AMENDMENTS TO THE DRAWINGS

REMARKS

FIG. 4A

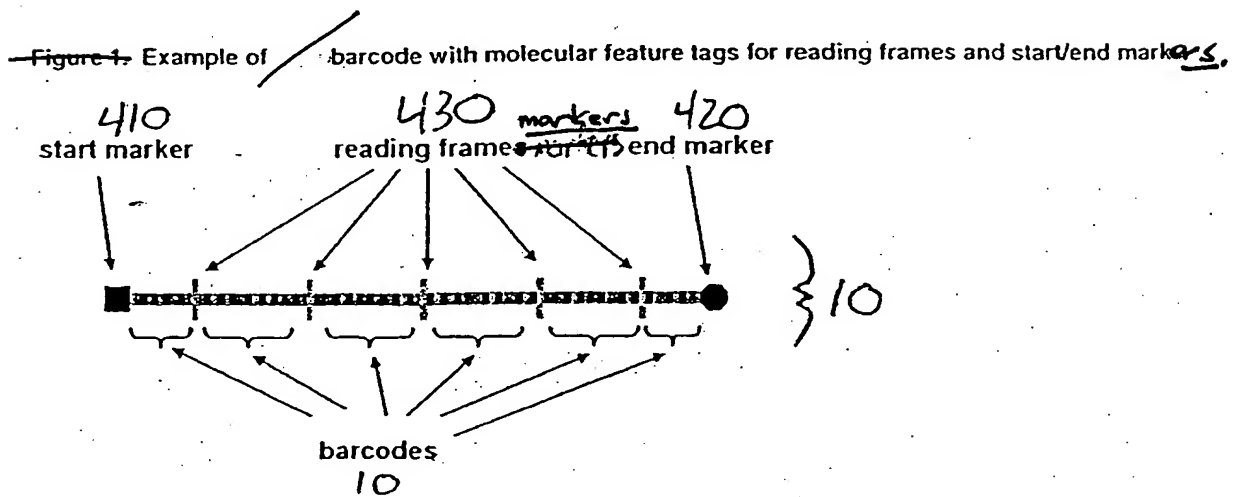
The attached sheets of drawings show changes to Figures 3 and 4. For Figure 3, a clearer copy of the photograph is provided. For Figure 4A, "Figure 1." and the space between "of" and "barcode" have been deleted. After "start/end", "marke" has been replaced with --markers--, and where "markers" has been written in after "reading frame", it has been replaced with type written --markers--. For Figure 4B, "Figure 2." and the space between "of" and "barcode" have been deleted. For Figure 4C, "Figure 3." and the space between "of" and "barcode" have been deleted. These replacement sheets replace the original sheets filed with the application.

Applicants have provided herewith corrected Figure 3, Figure 4A, Figure 4B, and Figure 4C.
